Nissan Technical Service Bulletins to help make diagnosing and servicing Nissan vehicles a little easier.

Title: 2002 Altima and Sentra: MIL “ON” and DTC P0340 (Camshaft Position Sensor Code) Stored

TSB: NTB01-074a

Figure 2.

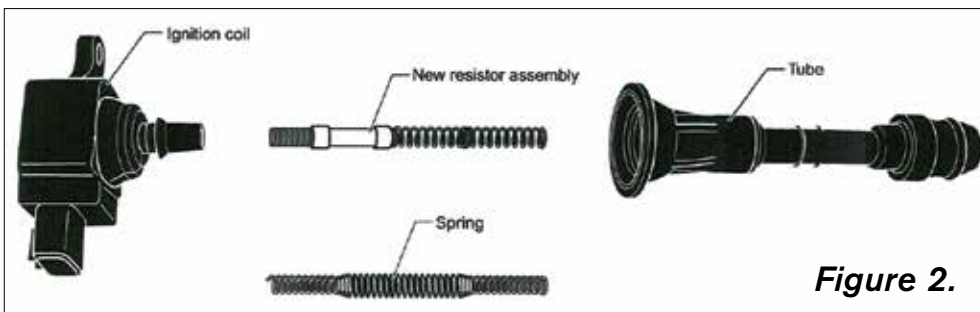
1. Verify that the vehicle has one or more of the symptoms listed above.
2. Remove all four ignition coils. Refer to the appropriate 2002 Service Manual for the removal procedure of the ignition coils (page EM-26 for Altima, page EM-106 for Sentra).
3. Install the new resistor assembly in all four ignition coils as follows:
 - A. Pull the rubber boot away from the ignition coil. Then, twist and pull the ignition coil tube from the ignition coil to separate them (Fig. 1).
 - B. Remove the spring from the ignition coil and discard. Insert the new resistor assembly into the ignition coil tube exactly as shown (Fig. 2).

Figure 3.

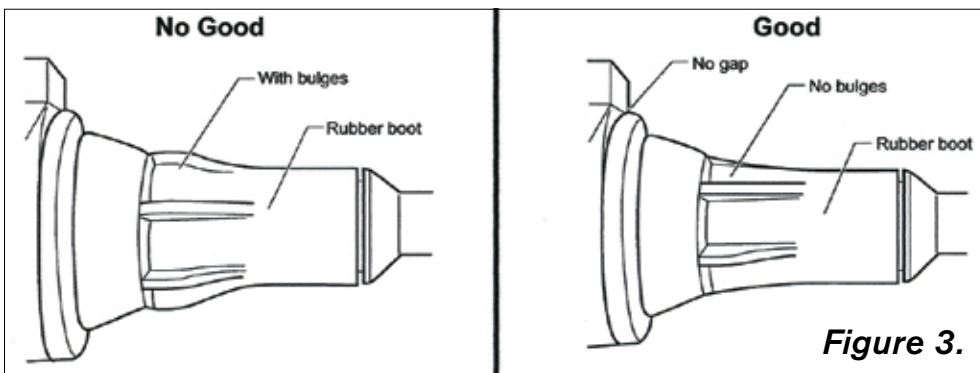
- C. Assemble the ignition coil tube to the ignition coil.
 - Rotate the ignition coil tube while pressing on to the coil.
 - A “pop” sound will be heard when the rubber boot is seated correctly to the ignition coil.
 - Ensure there are no gaps and bulges between the coil body and the rubber boot (Fig. 3).
4. Re-install the ignition coils with the new resistor

CMP sensor locations.

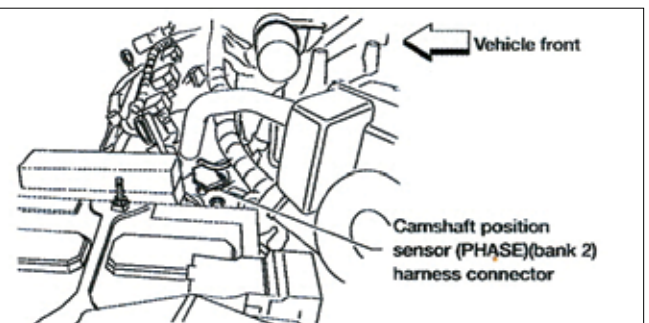
- If you have DTC P0340, replace only Bank 1 CMP (Camshaft Position) Sensor.
- If you have DTC P0345, replace only Bank 2 CMP (Camshaft Position) Sensor.
- If you have both codes, replace both sensors.
- For a "hard to start warm" incident, replace both sensors, even if you have no codes.
